POOL 2023-166640

PERMIT # OSWP-2022-7001

SEPTIC: IMPROVEMENT PERMIT / AUTHORIZATION TO CONSTRUCT / OPERATION PERMIT / EXISTING SYSTEM

SITE ADDRESS: 170 HIDDEN MEADOWS DR, MOORESVILLE, NC 28117 | PHONE: 7043101832 | ALT. PHONE:

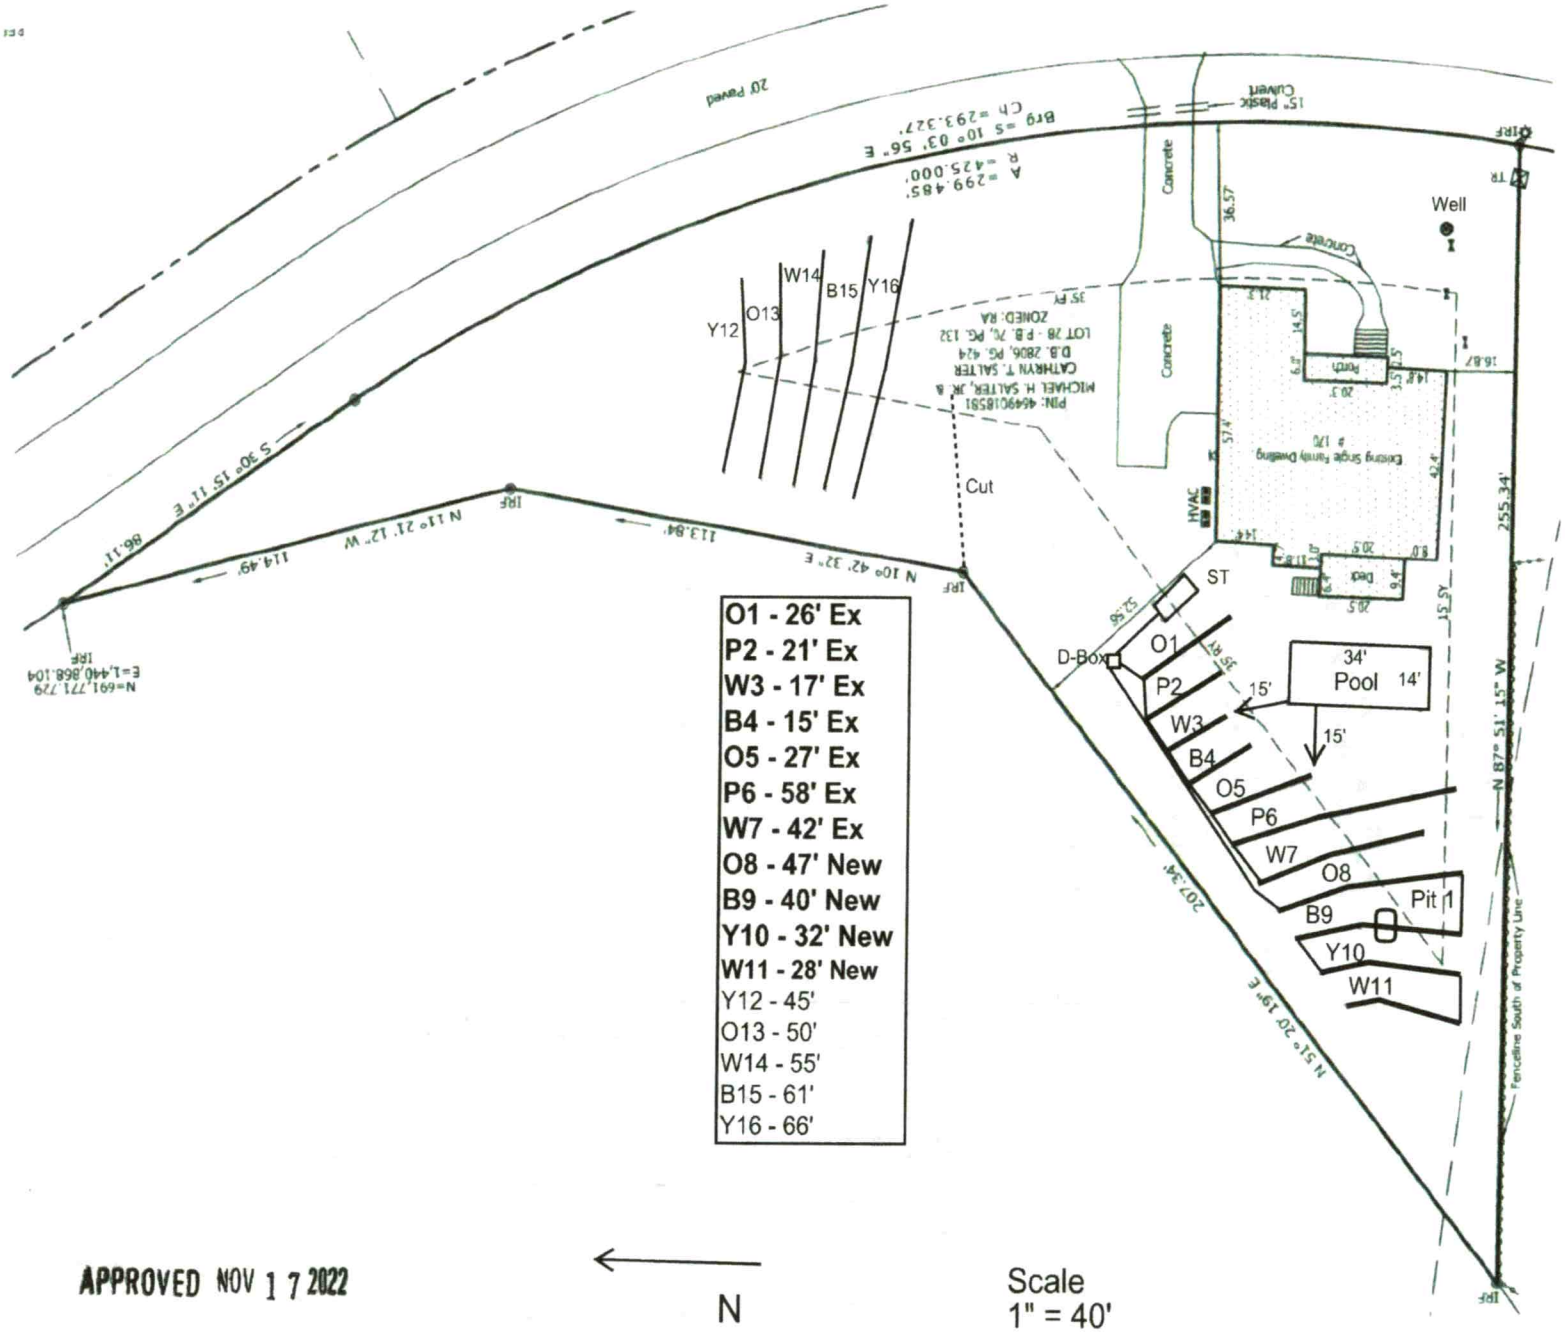
> **From:** "gary michaelathanas.com" <gary@michaelathanas.com>
> **Date:** November 3, 2022 at 6:39:50 AM PDT
> **To:** "brad tjpanel.com" <brad@tjpanel.com>
> **Subject: Design help**
>
> I have attached a design we submitted to the county. There is an existing chamber system we have to modify for a pool. I am adding Horizontal panels to make up for the loss of chambers. Trying to keep it gravity fed. As you can see, I have 4 unequal lines that I have on serial distribution, but I realize that it is basically a 147' line. If that works for you, I will leave it.
> I have thought of another option. I can set another d-box to divide the flow again. I would connect O8 and W11 (75') and connect B9 and Y10 (72').
> What do you think?
>
> Gary McNeely
> Michael Athanas & Associates
> (704) 310-1832

Russ
To clarify for Iredell county, we are proposing to use a distribution box to gravity feed two horizontal panel lines that are 75' and 72'. Both of these lines are comprised of two lines that are serial fed. This is the proposed option you are approving, correct?

Given these two options, our recommendation is that you use a distribution box to gravity feed two horizontal panel lines that are 75' and 72'. Both of these lines are comprised of two lines that are serial fed.

After looking over your proposed design, I honestly like the second option. Having two lines fed via another d-box would be our go to, especially considering how close in total line length they are. Please let us know if you have any questions.
